SUNDRY NOTICES AND REPORTS ON WELLS

Yates 8 Federal #2

XTO ENERGY, INC WOULD LIKE TO PROPOSE THE FOLLOWING PLUG BACK/RECOMPLETION FOR THE YATES 8 FEDERAL #2:

Conditions of Approval

PROPOSED DIAGRAM

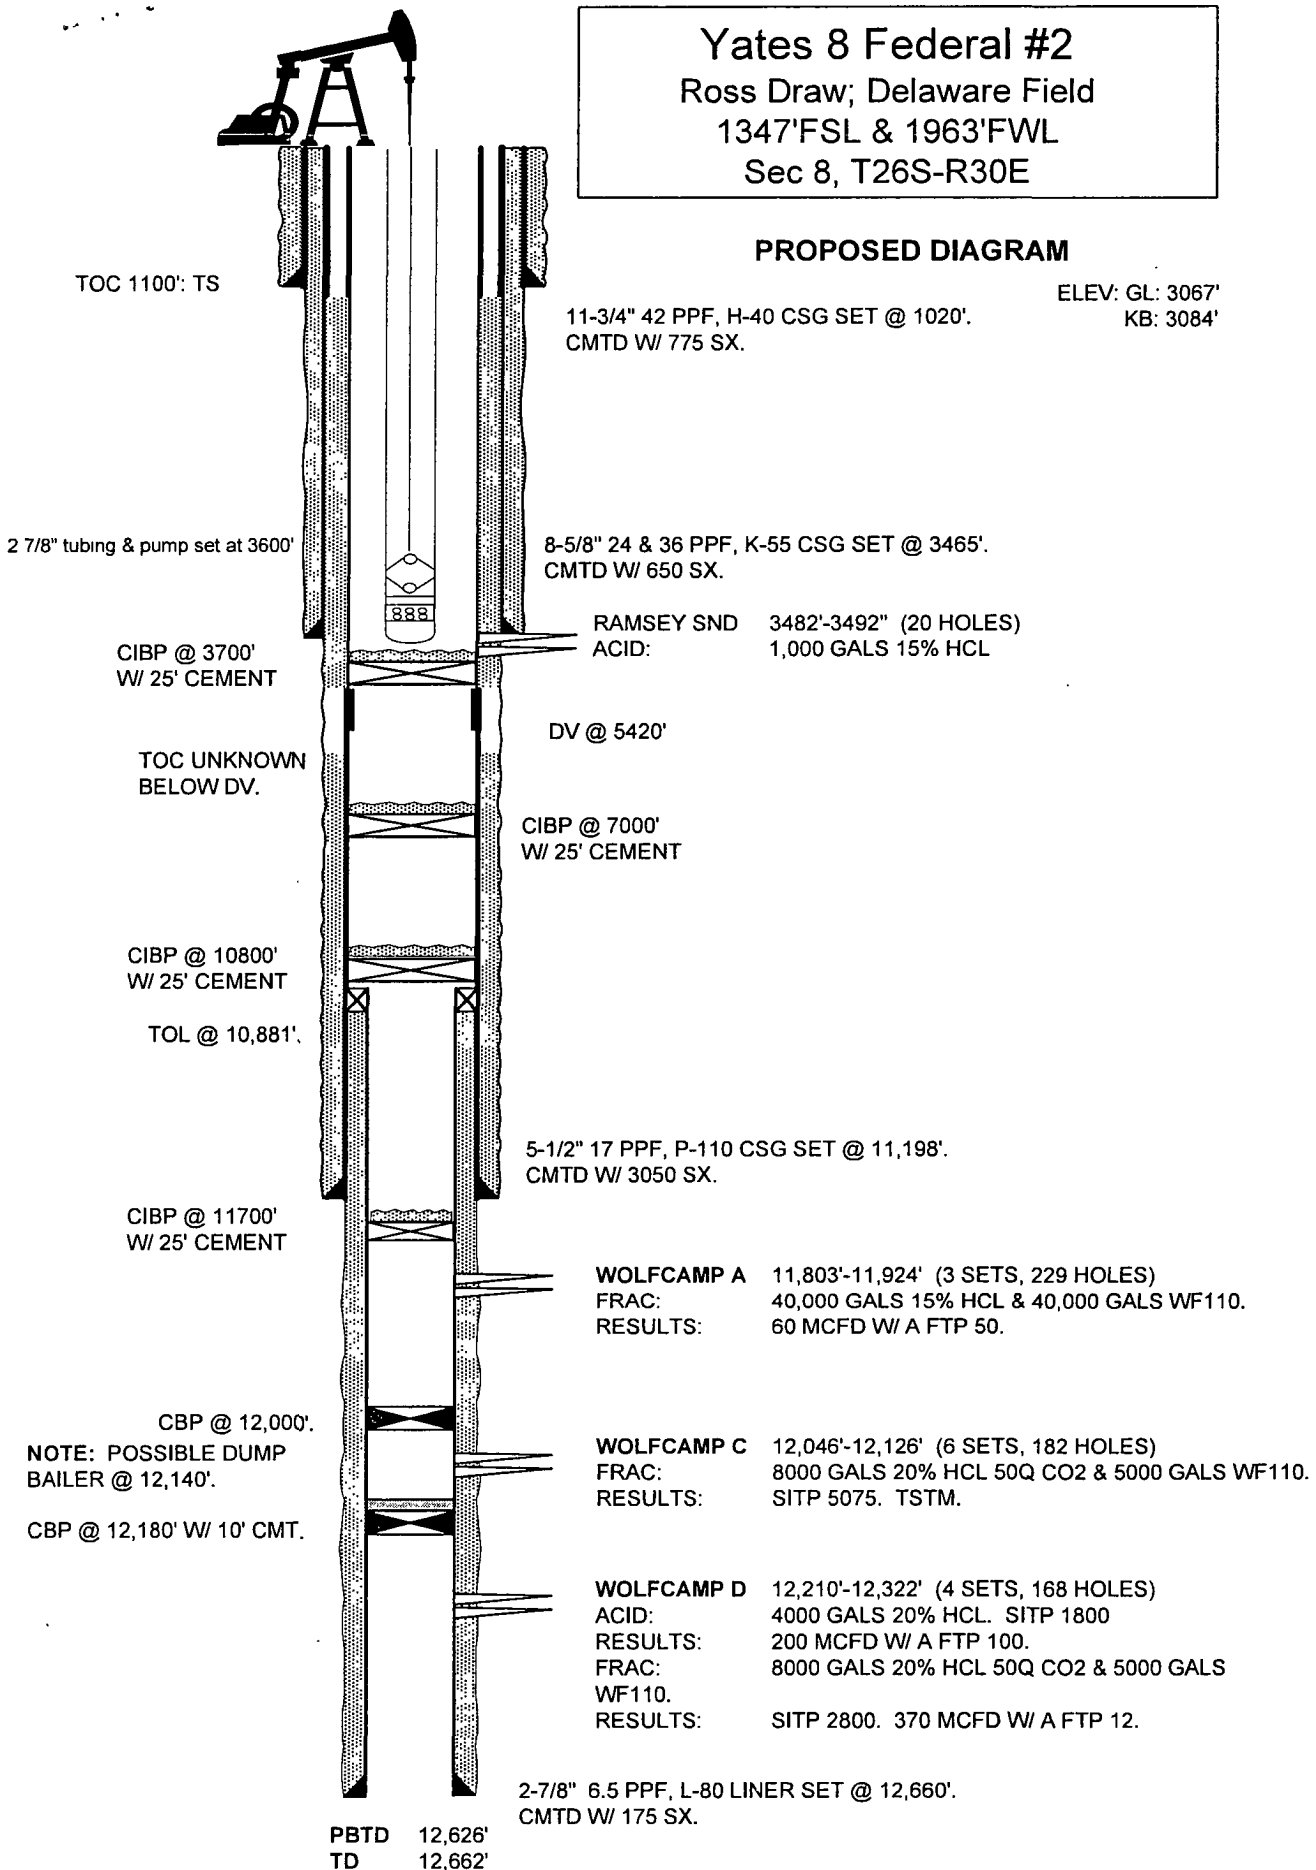
Note: The Ramsey Sand is in the Bell Canyon not the Cherry Canyon.

12. **Operator shall also drill out the packer assembly at 10,875'.**
13. **Step 2 of procedure will require a smaller CIBP as that is in the 2-7/8" liner. CIBP shall be set at 11,750' and a minimum of 30 sacks of Class H cement placed on top of the CIBP. This will cover the 5-1/2" shoe and the liner top at 10,881'. Plug shall be tagged at 10,800' or shallower. Plug shall be pressure tested to 1000 psi with test recorded on a chart and witnessed by the BLM.**

14. **Set a neat Class H cement plug across the top of the Wolfcamp. Plug shall be a minimum of 210' in length, a minimum of 25 sacks and shall be set from 10,550' to 10,340'.**

15. **Set a neat Class C cement plug across the top of the Bone Spring. Plug shall be a minimum of 175' in length, a minimum of 25 sacks and shall be set from 7,375' to 7,200'. Plugs shall be set so that there is no more than 3000' between plugs.**

16. **Set a neat Class C cement plug across the DV tool at 5,420'. Plug shall be a minimum of 155' in length, a minimum of 25 sacks and shall be set from 5,480' to 5,325'. Plug shall be tagged at 5,325' or shallower.**

18. **Operator's step 5 is not necessary, but if operator wants to set this 5-1/2" CIBP (not 8-5/8"), operator may set the CIBP, but is required to cap it with 35' of Class C cement. This will be tagged to verify 35' of cement.**
